**ADDENDUM 2****Addendum #** 2**Date Issued** January 27, 2026**Project Name | Job #** White Earth Withdrawal Management Facility | 20237410**Bid Date | Time** Tuesday, February 3, 2026 | 3:00 pm

THIS ADDENDUM AMENDS AND BECOMES PART OF THE CONTRACT DOCUMENTS FOR EAPC PROJECT 20245580 DATED 12/5/2025, RESPECTIVELY. EACH BIDDER SHALL ACKNOWLEDGE RECEIPT OF THIS ADDENDUM BY MARKING THE ADDENDUM NUMBER AND DATE ON THE BID FORM.

DRAWING TITLE
ROOF PLAN
A221

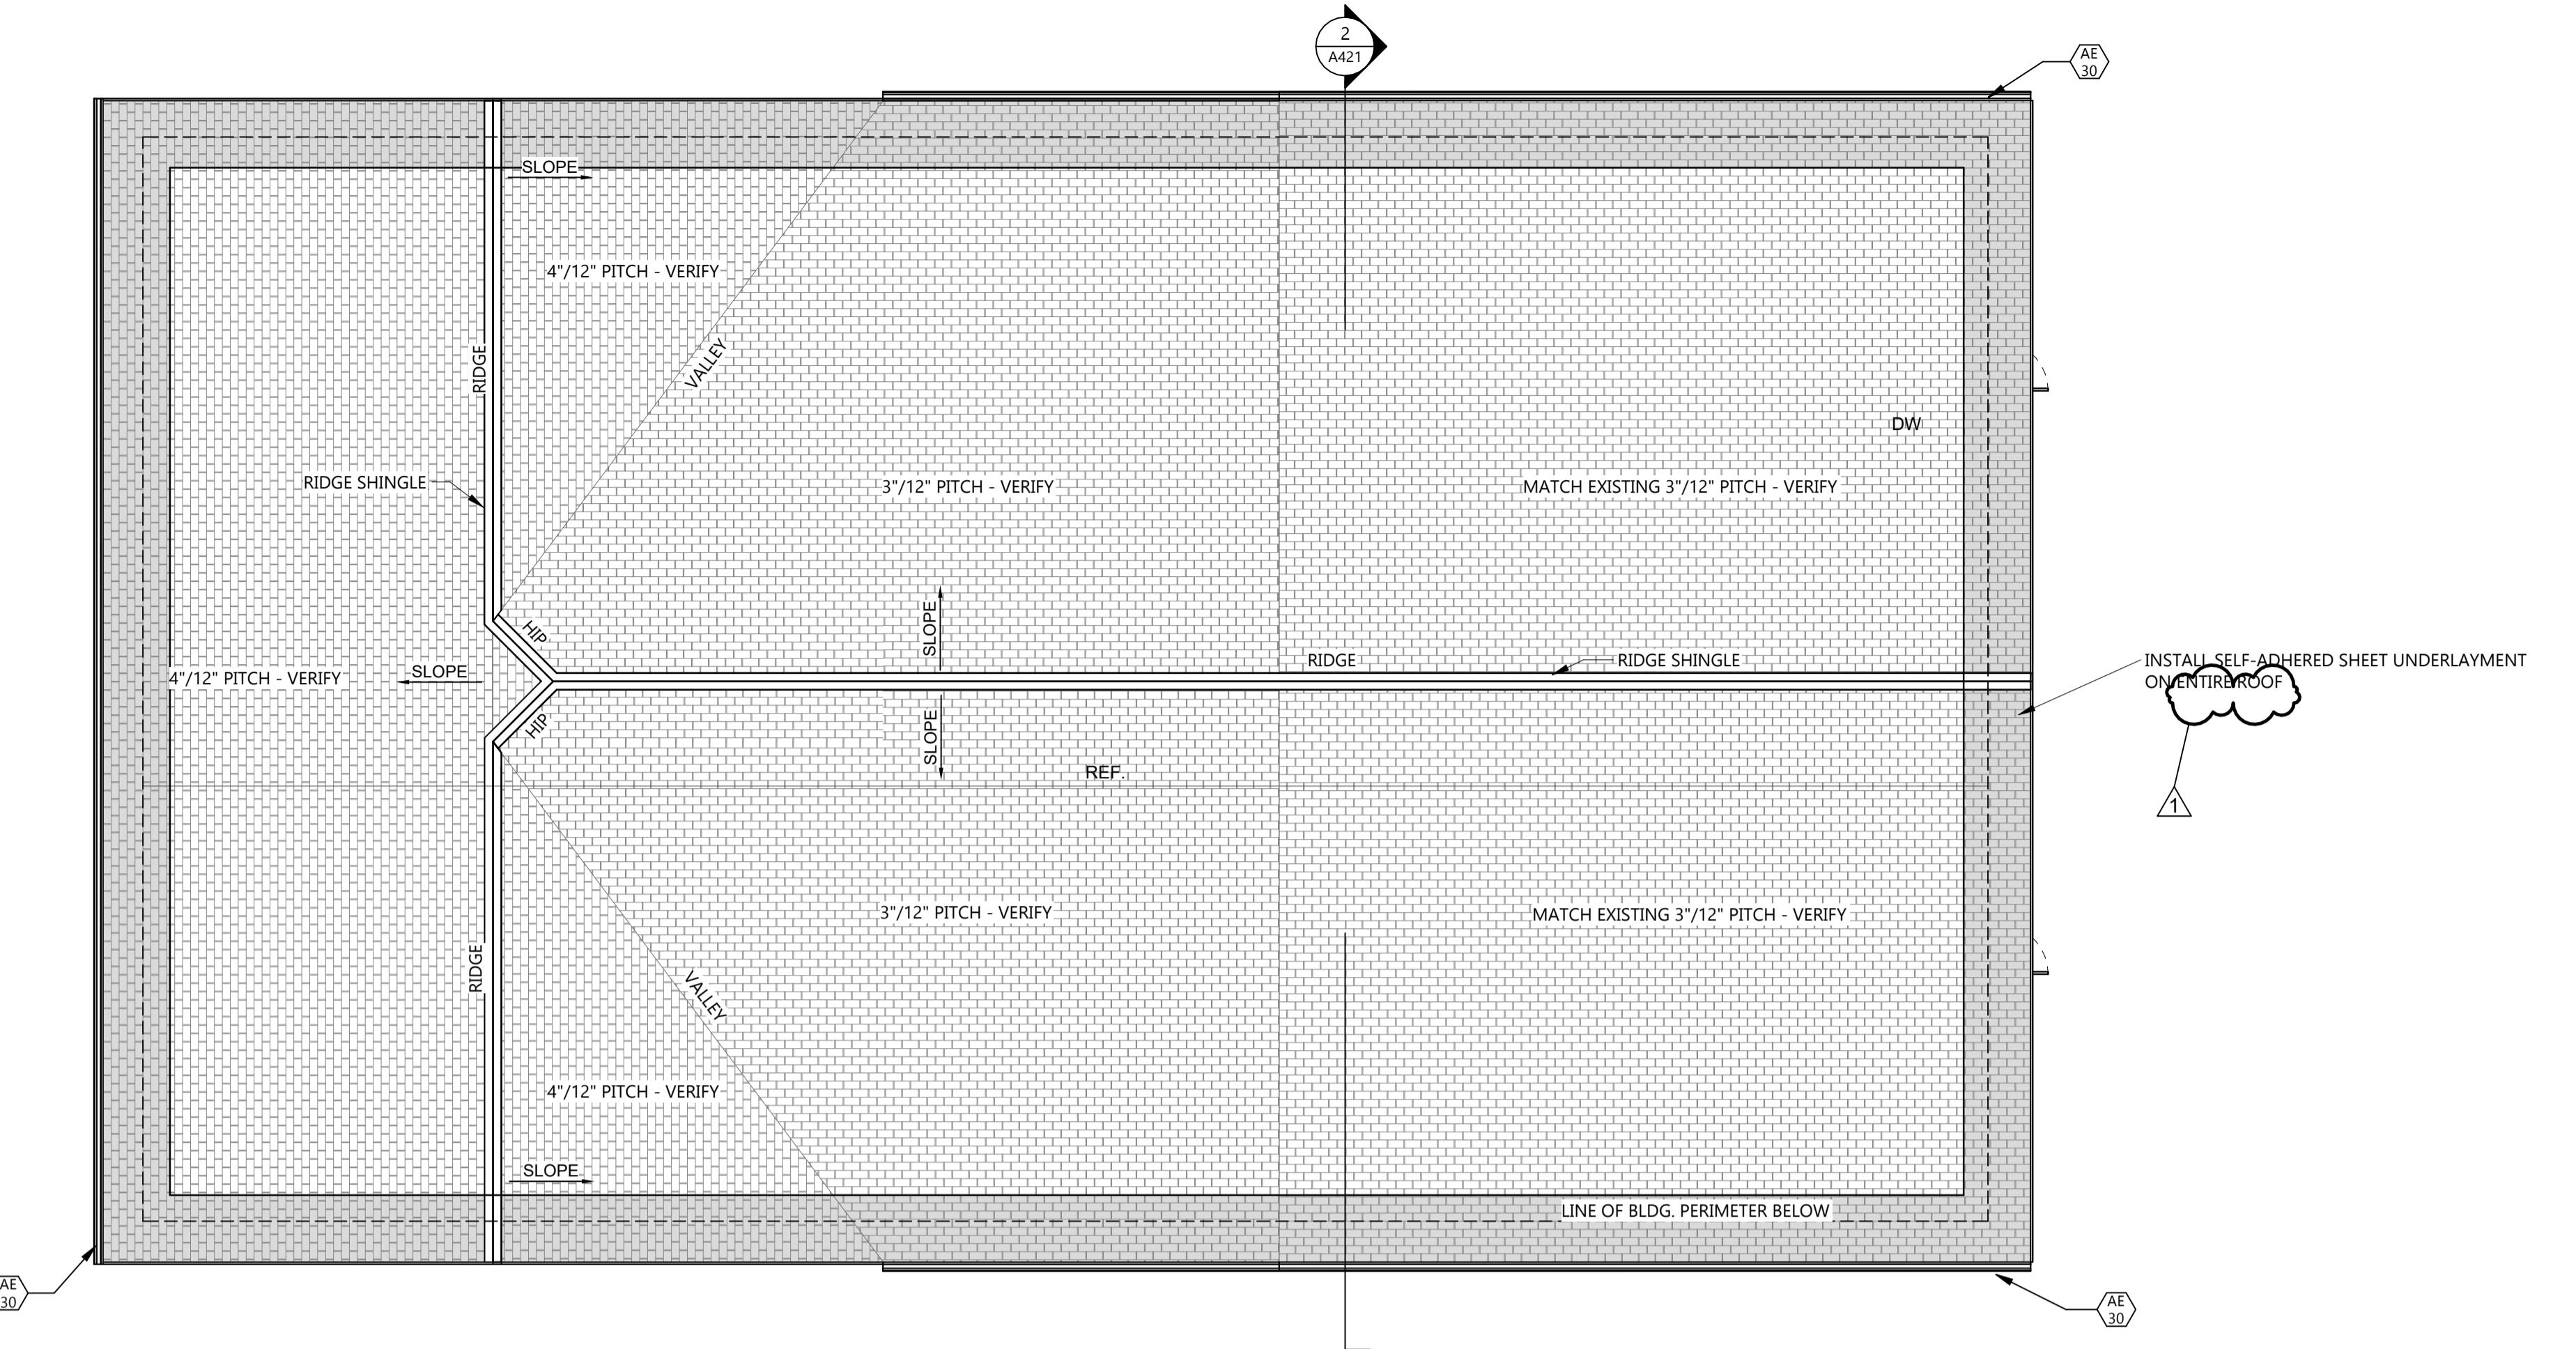
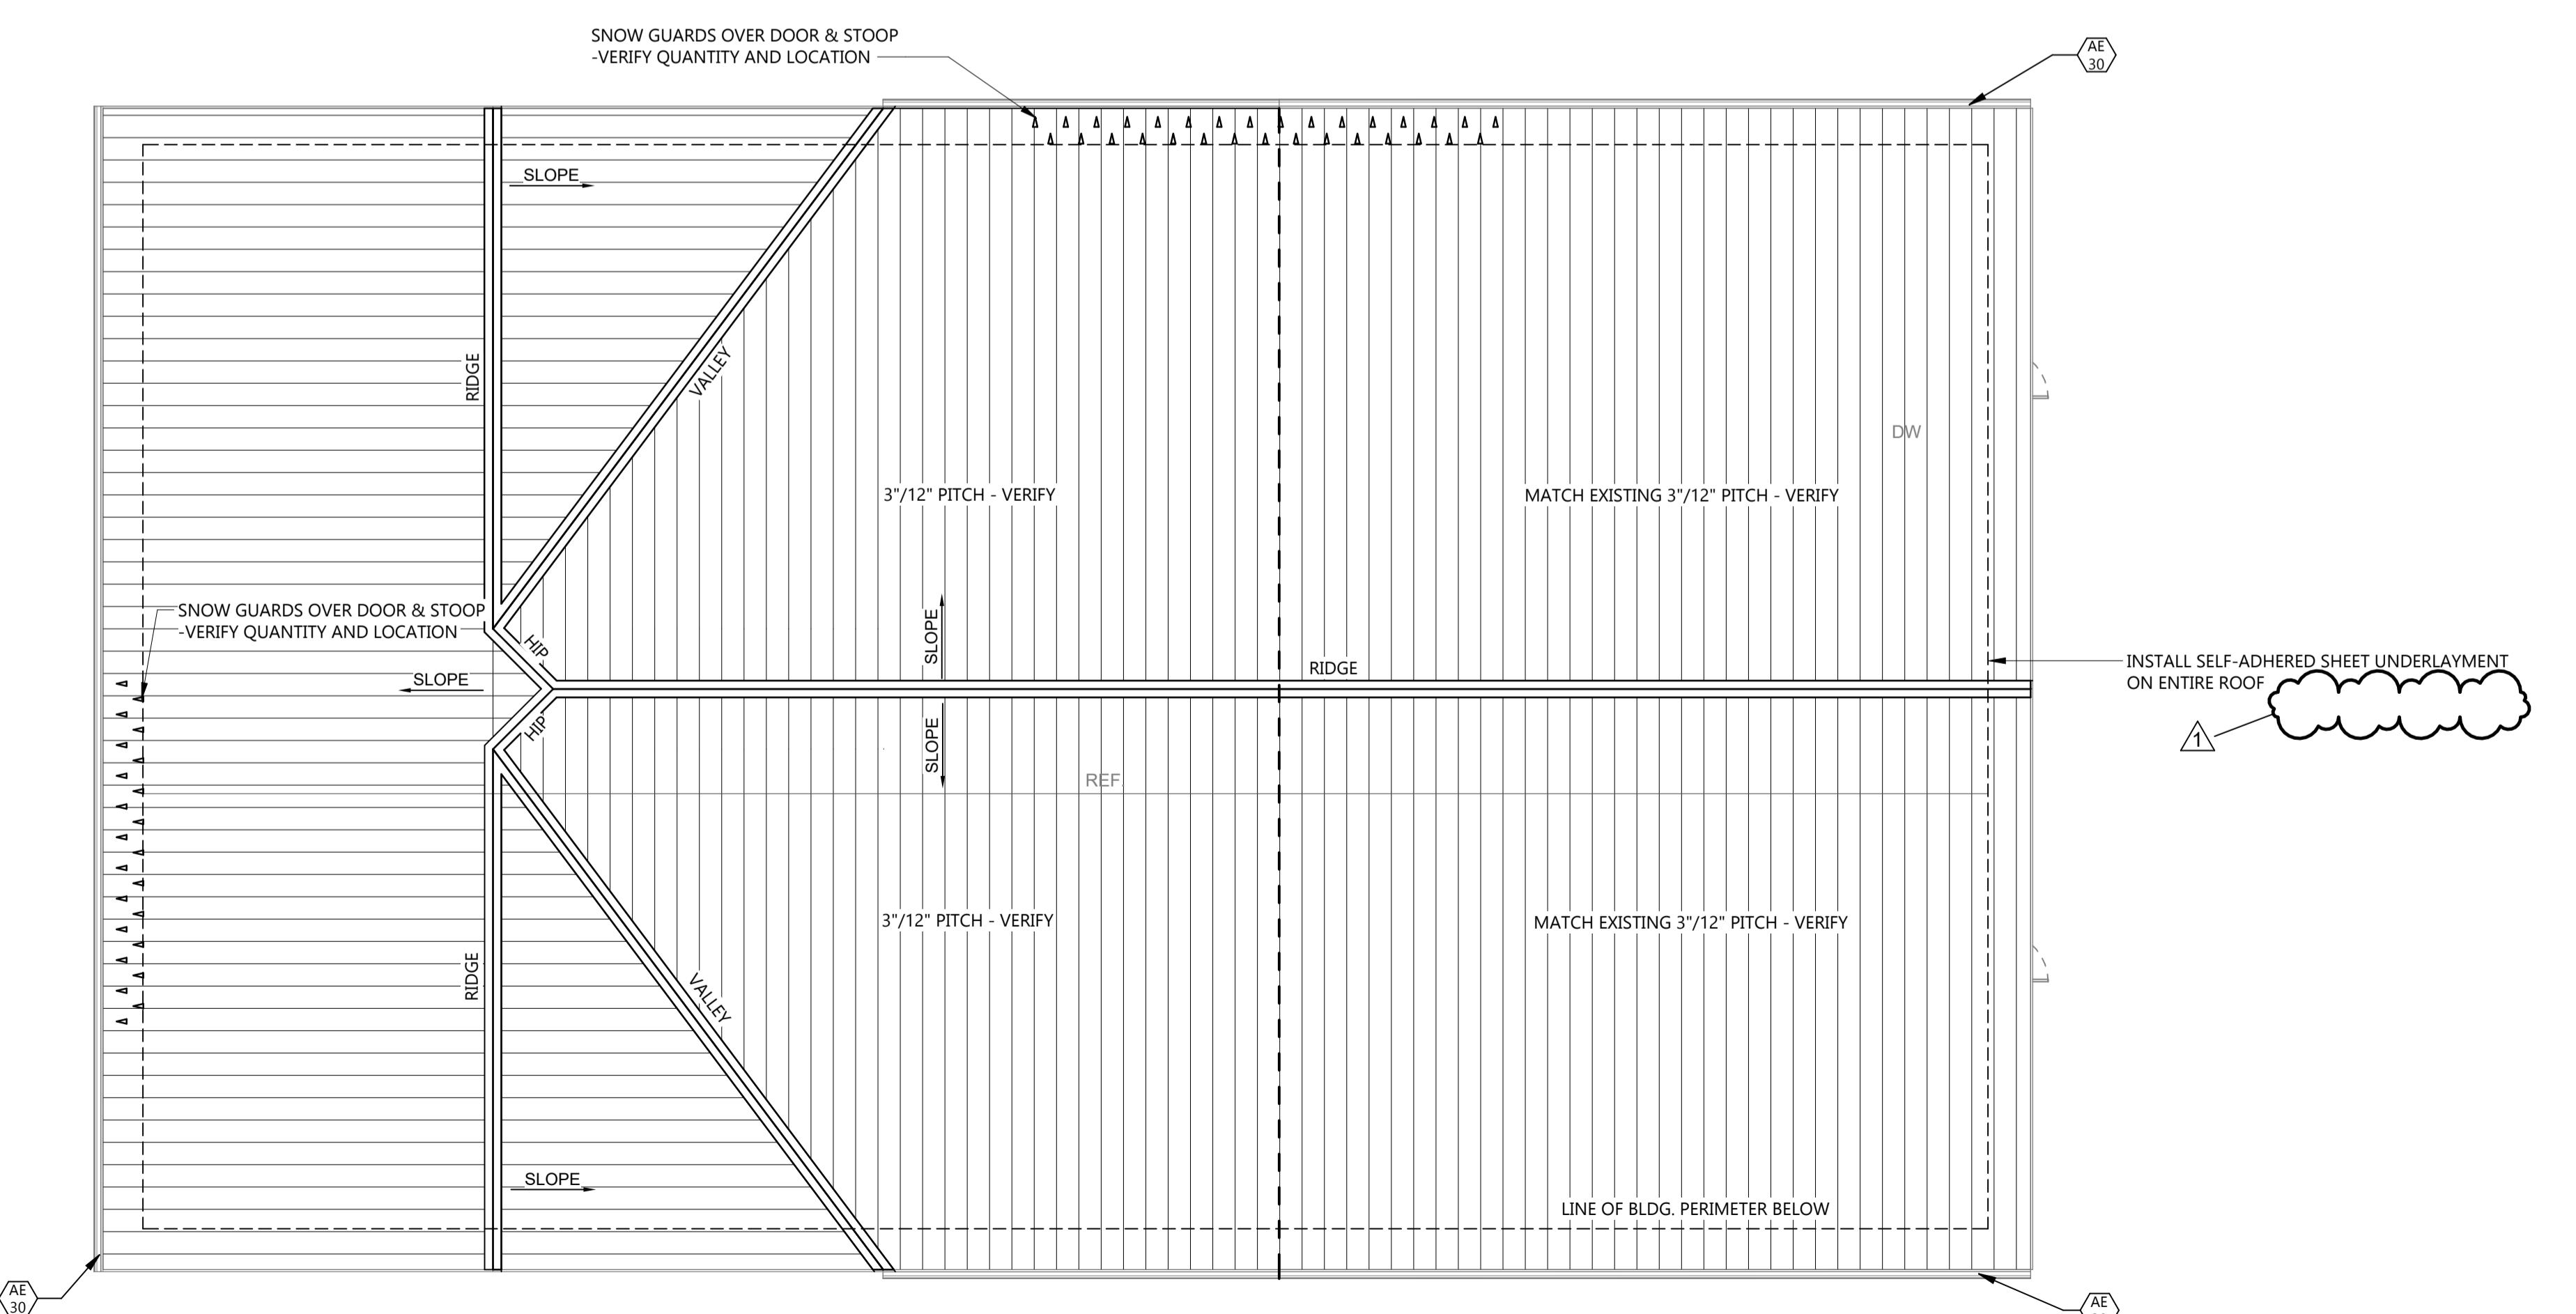
A221 Modify note at 1/A221 to read underlayment at entire assembly. Modify note at 2/A221 to remove "AT ADD ALTERNATE ONLY"

A301

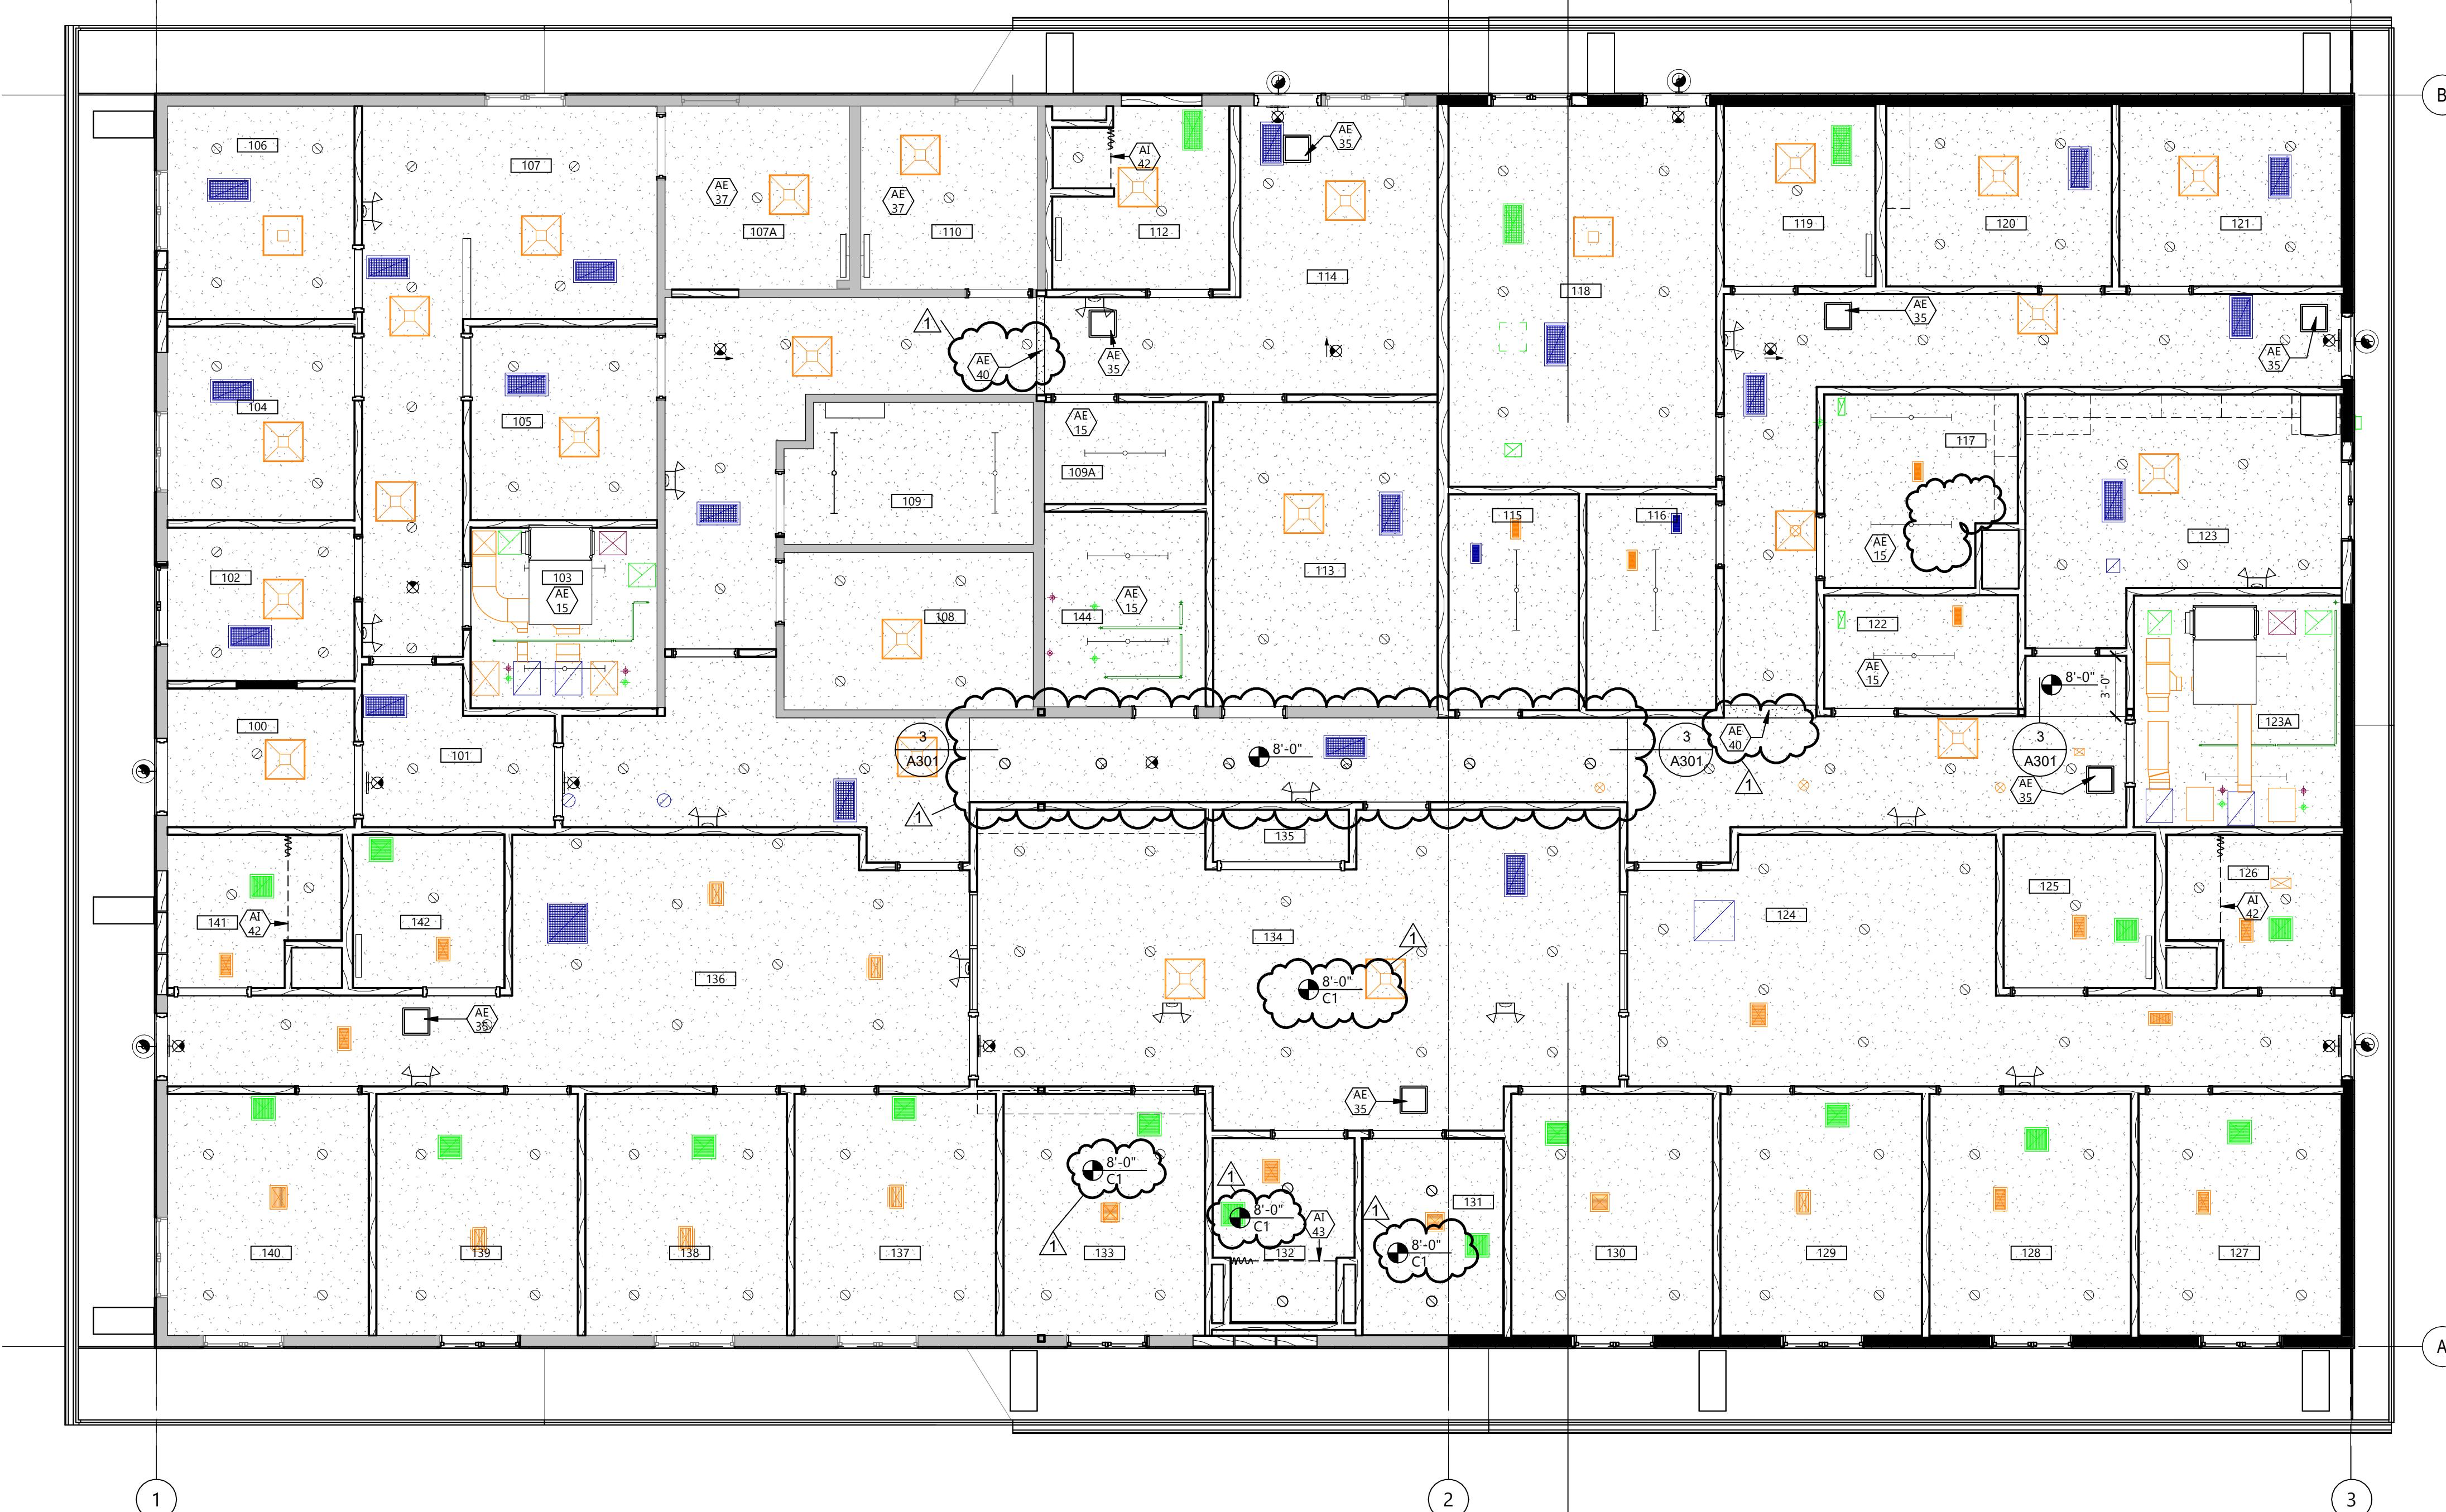
A301 Remove ceiling access panel at room 117. Modify ceiling at room 134 to 8'-0" framed GWB ceiling.
